CALL NO. 200
CONTRACT ID NO. 111024
ADDENDUM # 2

Subject: Christian County, 024GR11D024-IM & JL03
Letting May 20, 2011

(1) Revised - Plan Sheets - R2, R2A, R2B, R2C, R2D, R2F, & R2H

I-24 / US 41A INTERCHANGE I-24 TYPICAL SECTIONS

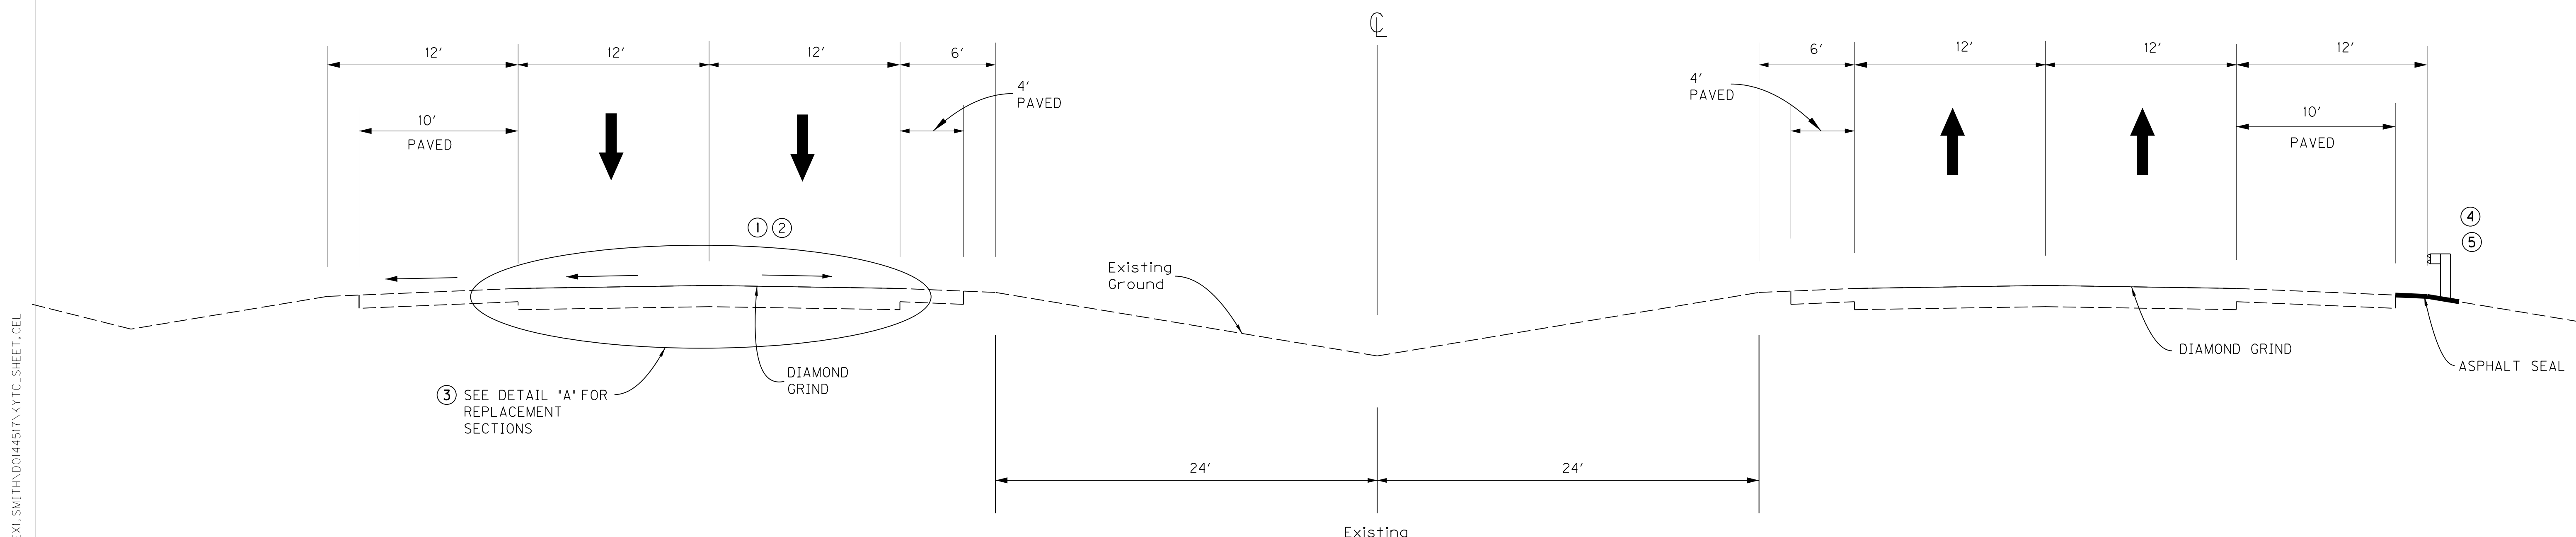
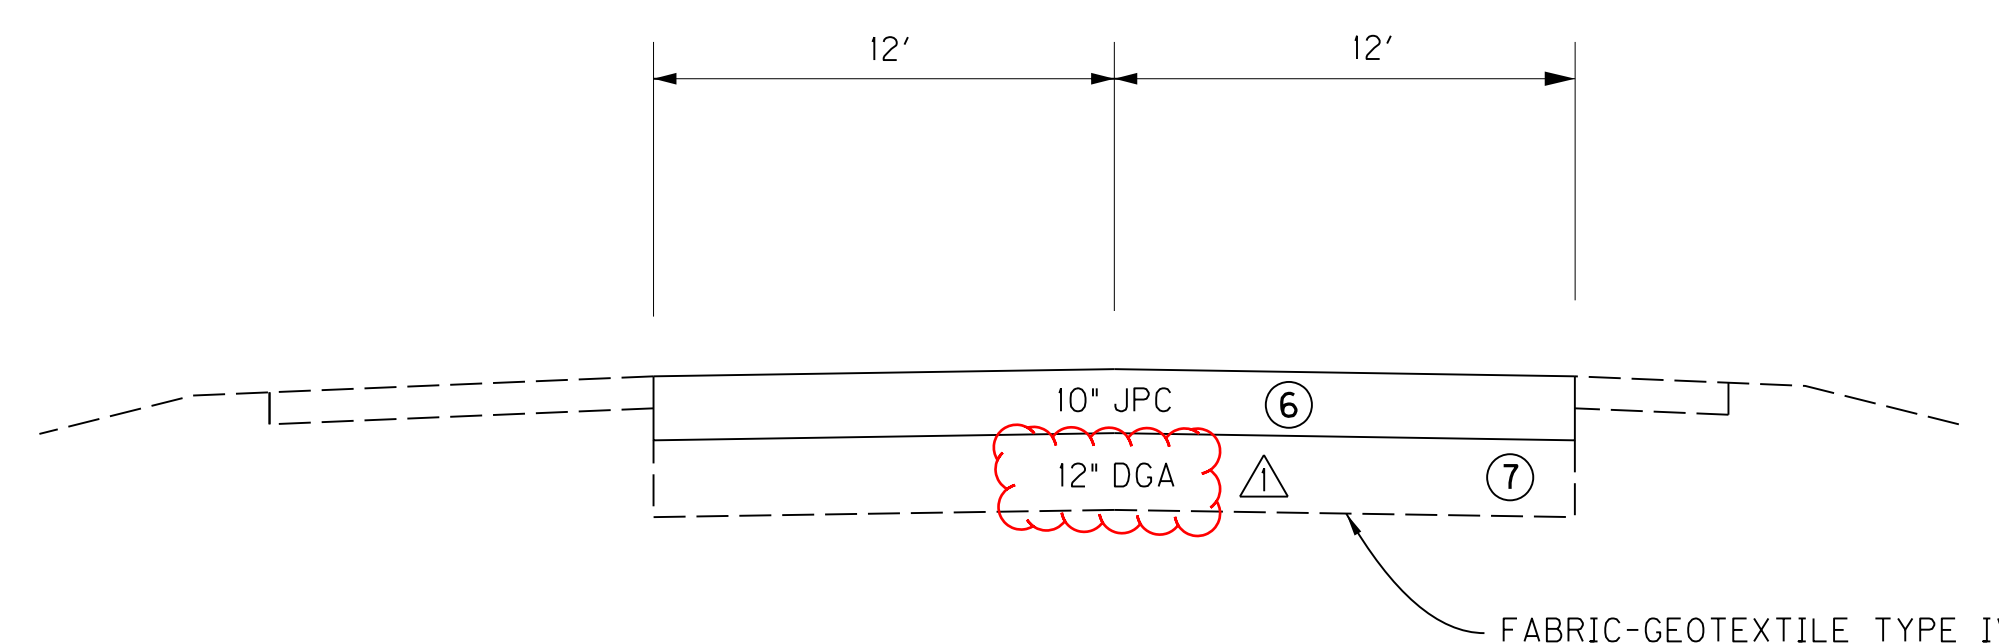
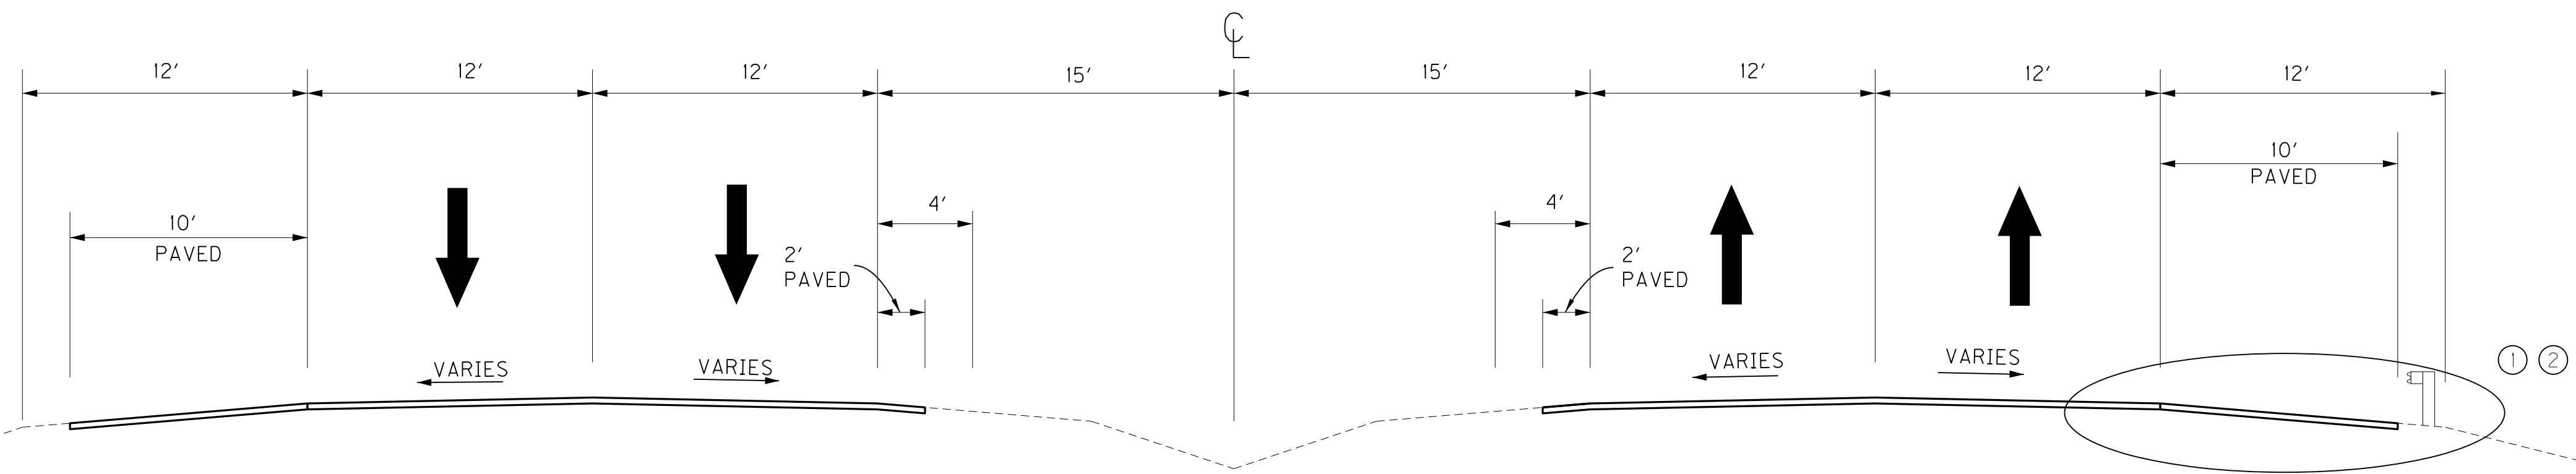
- ⑦ IF UPON EXCAVATION OF THE EXISTING CONCRETE PAVEMENT THE RESIDENT ENGINEER DETERMINES THE SUBGRADE TO BE UNSUITABLE, THE CONTRACTOR WILL EXCAVATE 12", OR DEPTH DIRECTED BY ENGINEER, AND CONSTRUCT EQUIVALENT DEPTH OF DGA OVER FABRIC-GEOTEXTILE TYPE IV. △

IF SUBGRADE STABILIZATION IS REQUIRED:
- 12" OR DEPTH DIRECTED BY ENGINEER DGA △
- FABRIC-GEOTEXTILE TYPE IV

I-24 /US 41A INTERCHANGE RAMP TYPICAL SECTIONS

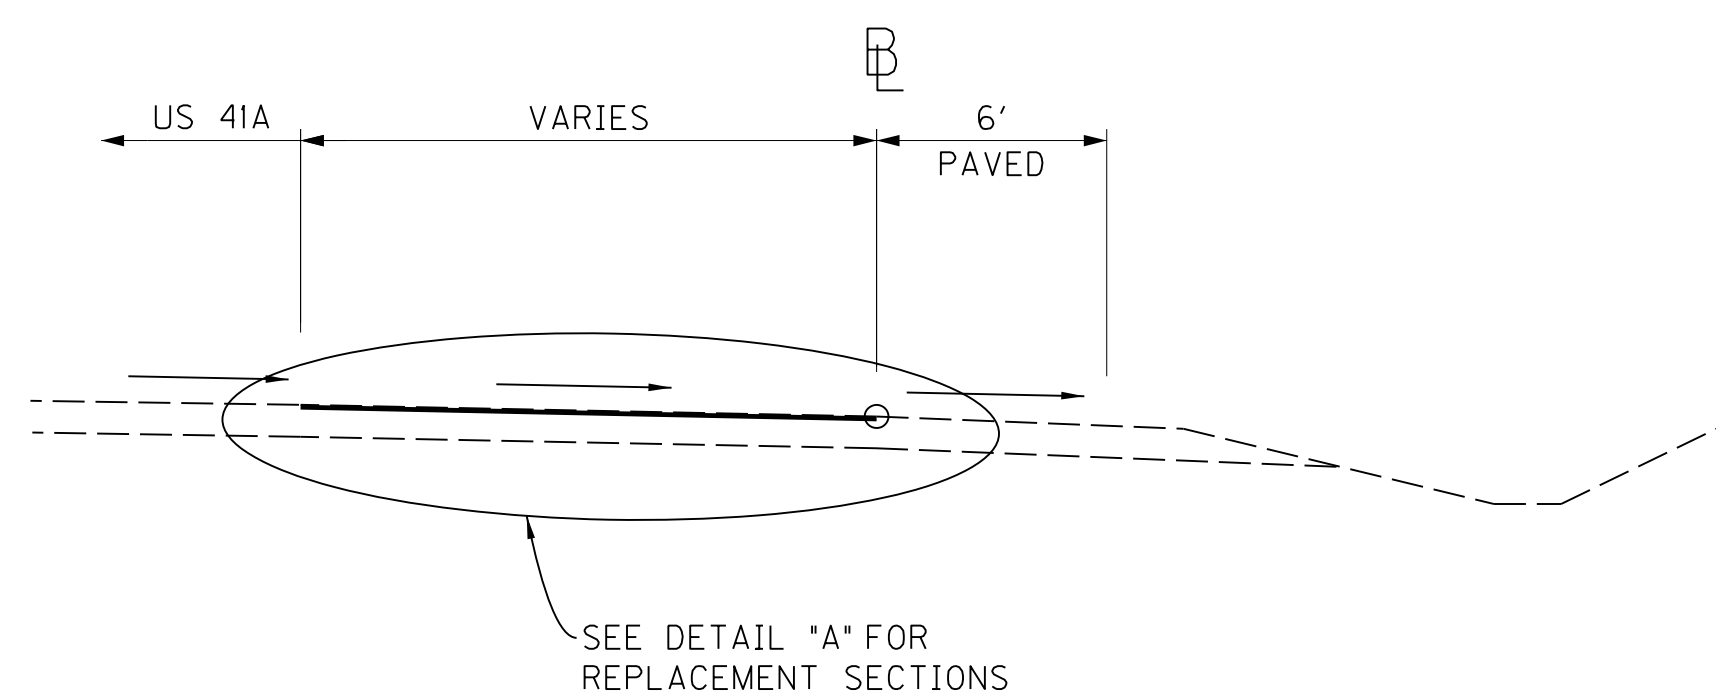
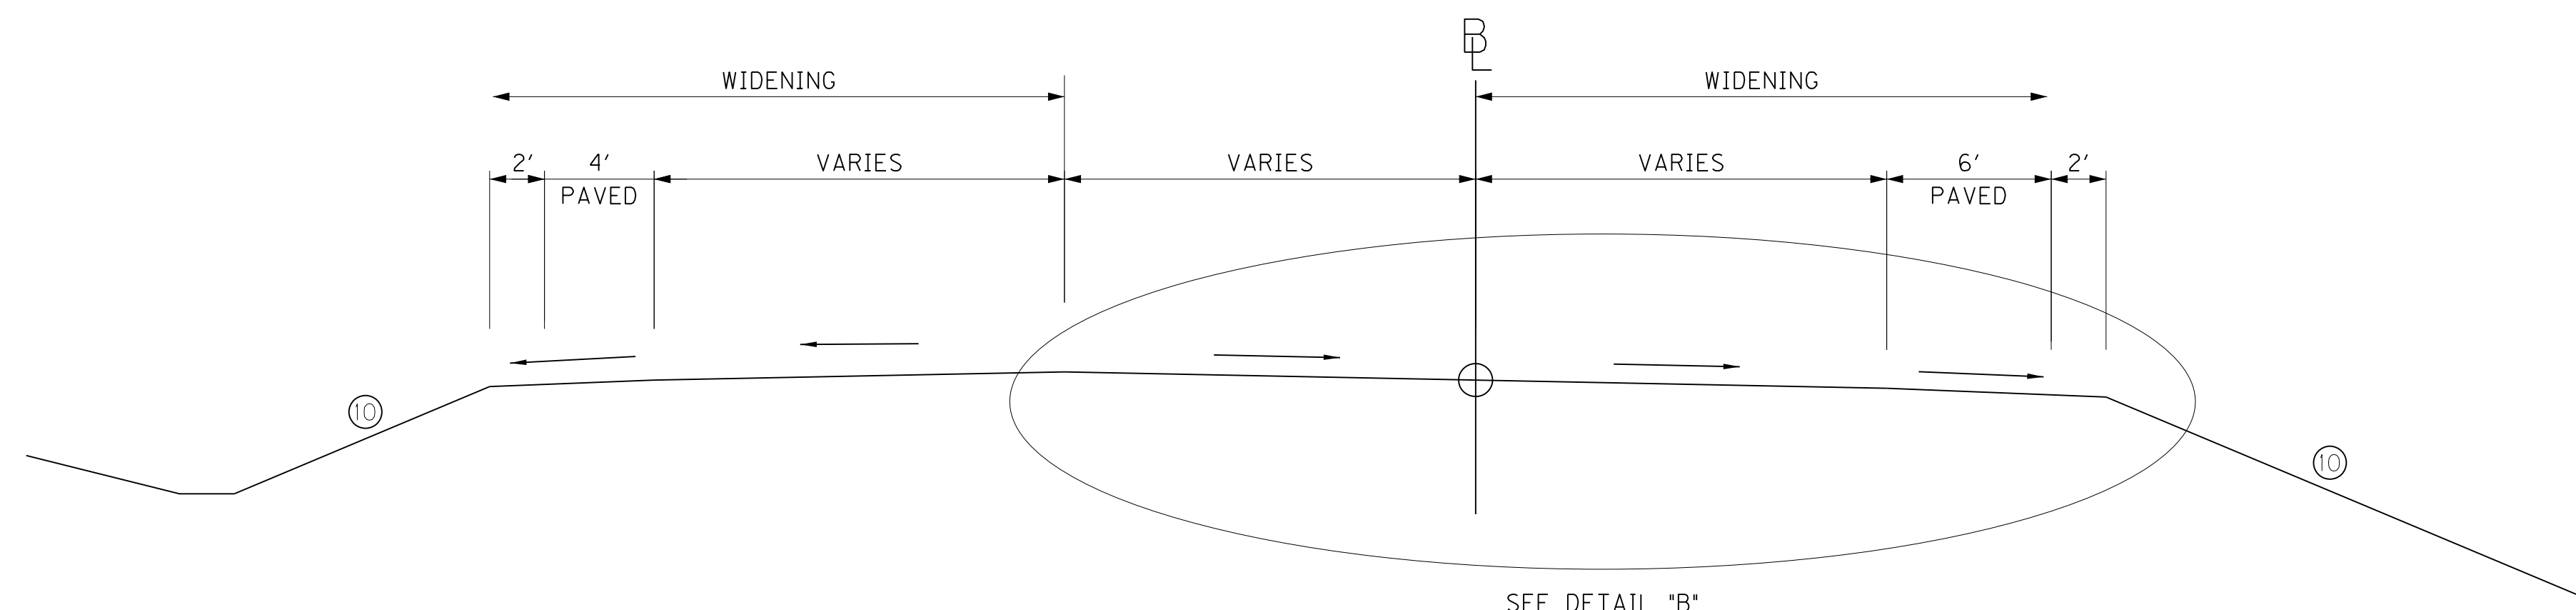
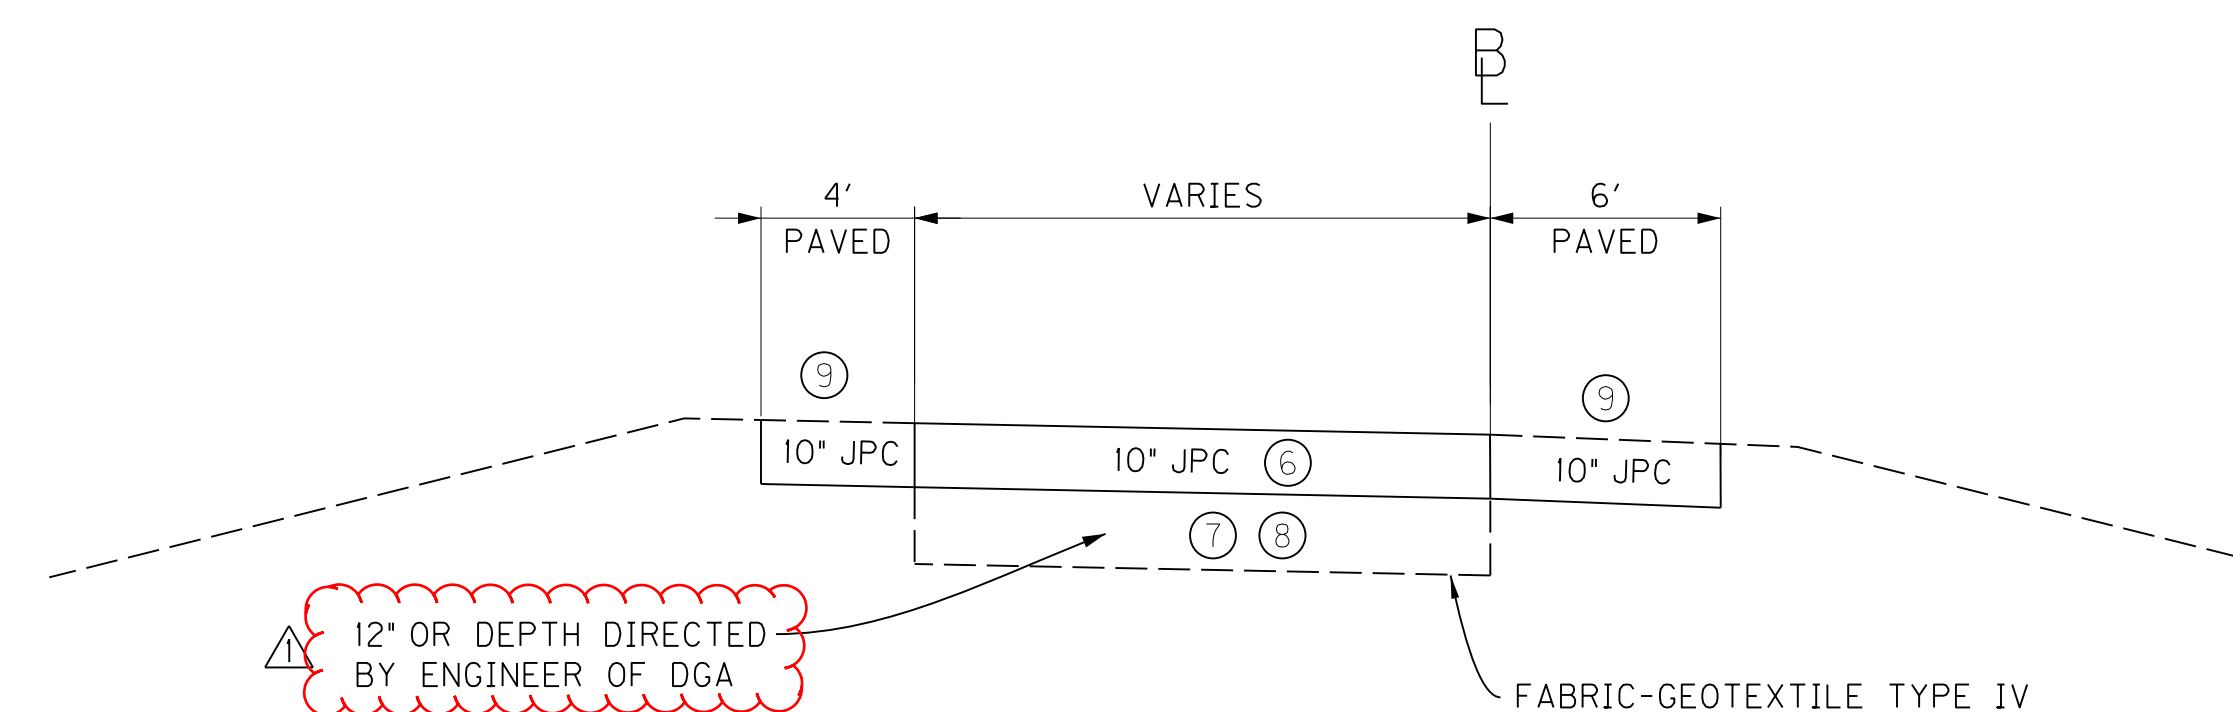
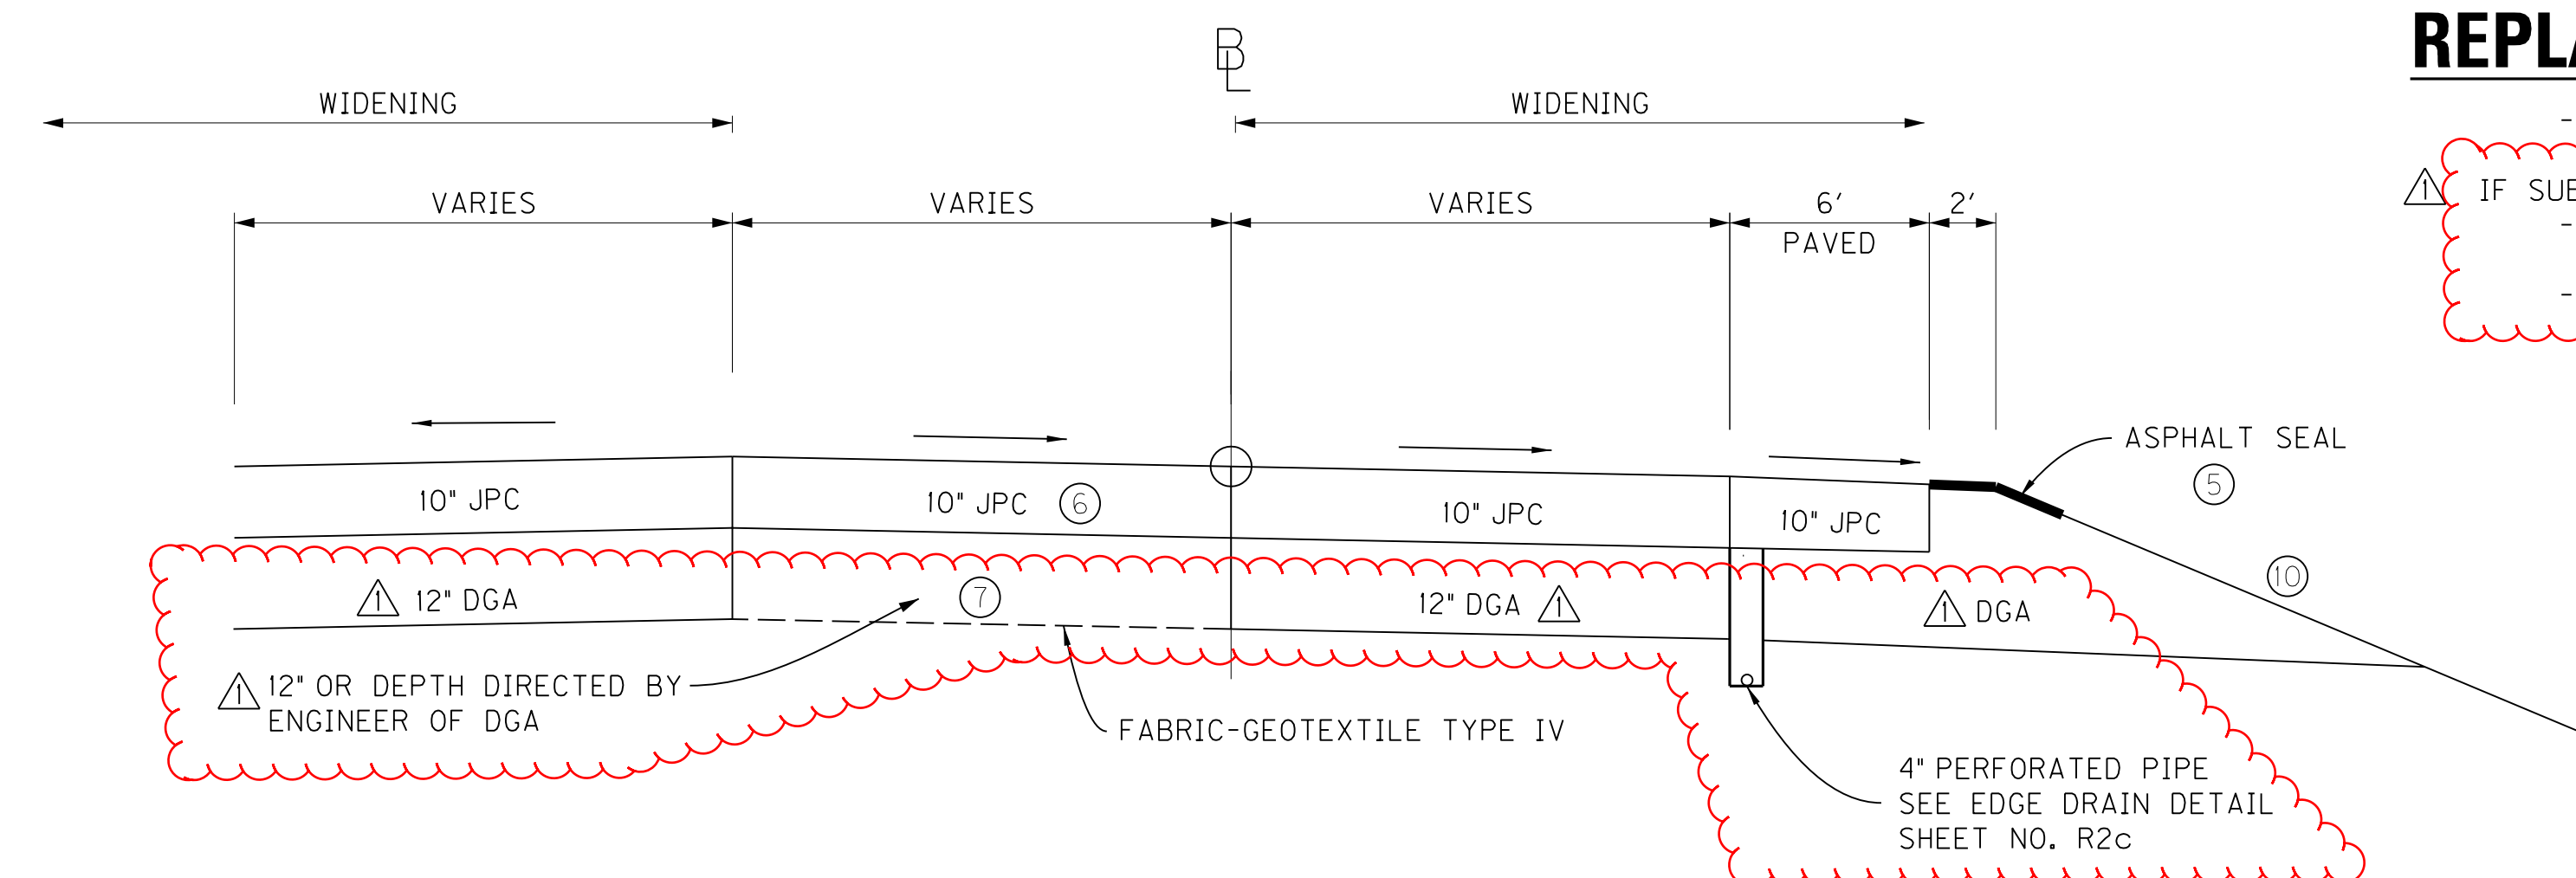
- 10" JPC
- △ IF SUBGRADE STABILIZATION IS REQUIRED:
 - 12" OR DEPTH DIRECTED BY ENGINEER OF DGA
 - FABRIC-GEOTEXTILE TYPE IV
